RECOMMENDED SERVICE BULLETIN

RSB 42-139

RSB 42NG-081

Replacement of rudder T-yoke axle with improved design.

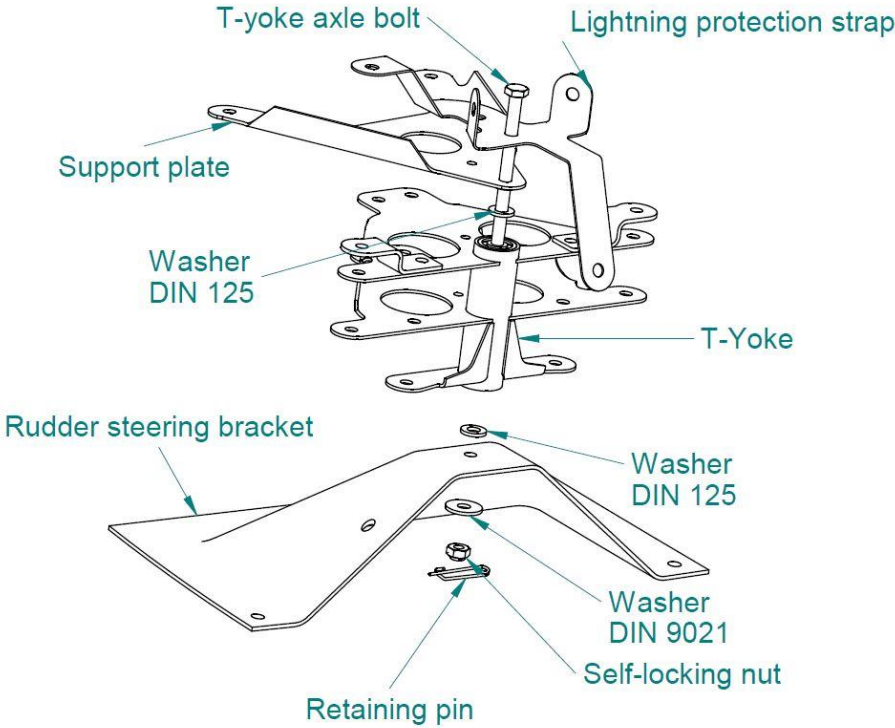
6.	Check the clearances while moving the rudder in both directions • between end of T-yoke bolts for copilot's right rudder cable & pilot's left rudder cable and nose landing gear (NLG) steering rod (continuous circle in picture 4) • and between head of T-yoke bolts for copilot's right rudder cable & pilot's left rudder cable and support plate (dashed circle in picture 4). Record the measured clearances. Each clearance must be greater than 2 mm (0.08 in). Pictures 1 – 4 show the affected area.  picture 1  picture 2  picture 3  picture 4

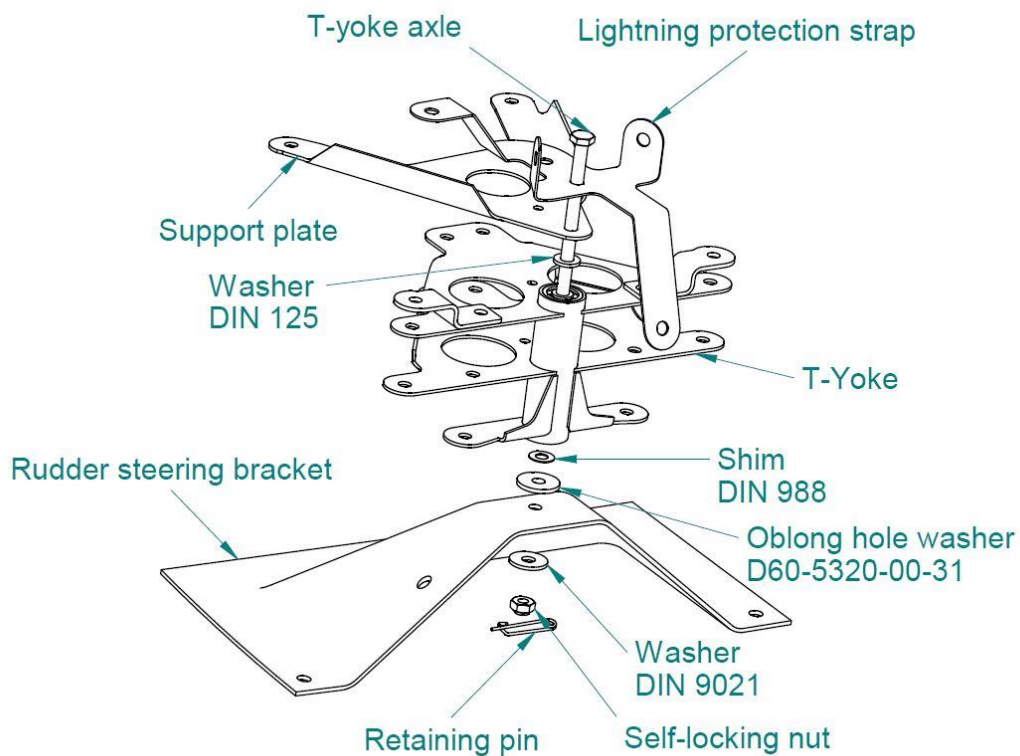
1.	Install the T-yoke with - the new T-yoke bolt D60-5320-00-32, - a DIN 125 washer between support plate and T-yoke, - a DIN 125 washer between the T-yoke and the rudder steering bracket, - a DIN 9021 washer between the self-locking nut and the rudder steering bracket, - a new self-locking nut and - a retaining pin AN416-1 perpendicular to the flight direction in accordance with figure 2. Note: The retaining pin can damage the heating hose if not installed perpendicular to the flight direction.  figure 2

figure 3

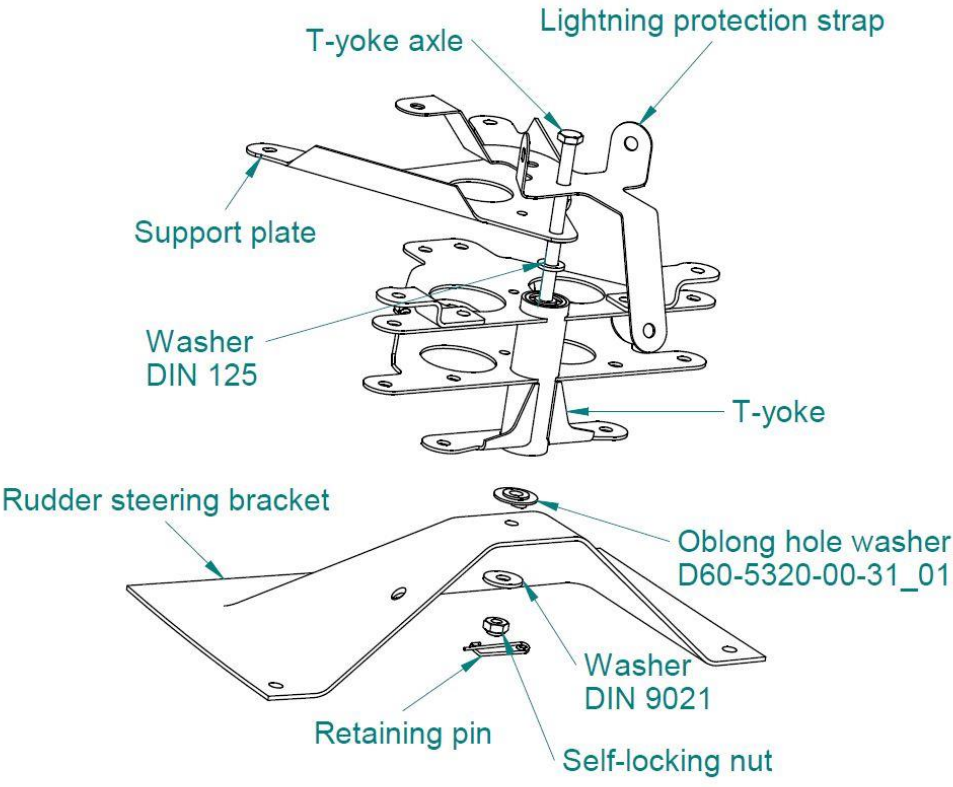
- the new T-yoke bolt D60-5320-00-32,
- a DIN 125 washer between support plate and T-yoke,
- a DIN 988 shim between the T-yoke and well bonded oblong hole washer,
- a DIN 9021 washer between the self-locking nut and the rudder steering bracket,
- a new self-locking nut and
- a retaining pin AN416-1 perpendicular to the flight direction

in accordance with figure 3.

Note: The retaining pin can damage the heating hose if not installed perpendicular to the flight direction.
